Safety Recall

Code: 1902

Audi

Subject	After-Run Coolant Pump																
Release Date	March 12, 2019																
REVISION SUMMARY	<p>Work instructions have been updated to inspect the coolant pump connector for damage.</p> <p>Claiming instructions have also been updated.</p>																
Affected Vehicles	<p>U.S.A.: Certain 2012-2017 MY Audi vehicles with a 2.0L TFSI gasoline engine</p> <p>CANADA: Certain 2013-2017 MY Audi vehicles with a 2.0L TFSI gasoline engine</p> <p><i>Check Campaigns/Actions screen in Elsa on the day of repair to verify that a VIN qualifies for repair under this action. Elsa is the <u>only</u> valid campaign inquiry & verification source.</i></p> <ul style="list-style-type: none"> ✓ Campaign status must show "open." ✓ If Elsa shows other open action(s), inform your customer so that the work can also be completed at the same time the vehicle is in the workshop for this campaign. 																
Problem Description	In certain vehicles with a 2.0L TFSI gasoline engine, the electric (after-run) coolant pump may short circuit and/or overheat, potentially leading to a vehicle fire.																
Corrective Action	Install a new electric (after-run)

Installing new after-run coolant pump -V51-

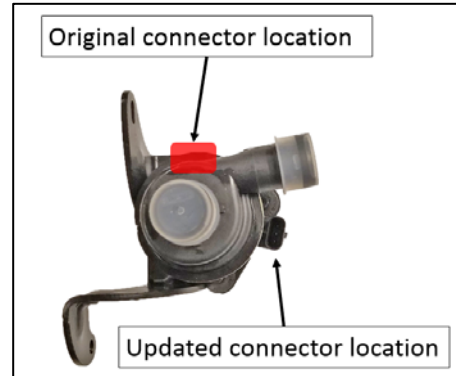
Due to the new location of the connector on the new pumps, the after-run coolant pump wiring harness <arrow> may have to be routed so it does not come into contact with the pump coolant hose.
